ATTACHMENT C -- PROPOSED DRAWING CHANGES

(MARKED-UP SPECIFICATION)

original of the Fig. 4

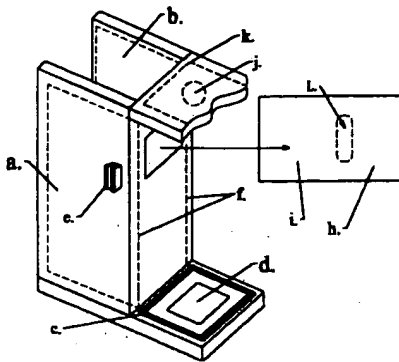
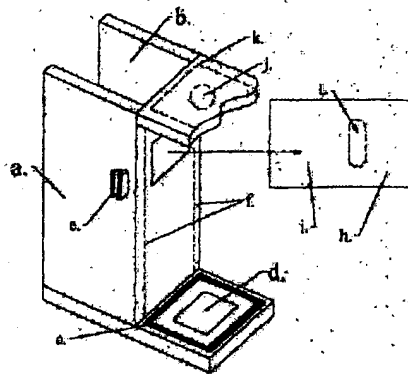
Amend of the Fig. 4
(prolong the dotted line)

Approval of the proposed drawing changes marked in red on the following copies of Figures x-y and prolong the dotted line of Fig.4 f are respectfully requested.
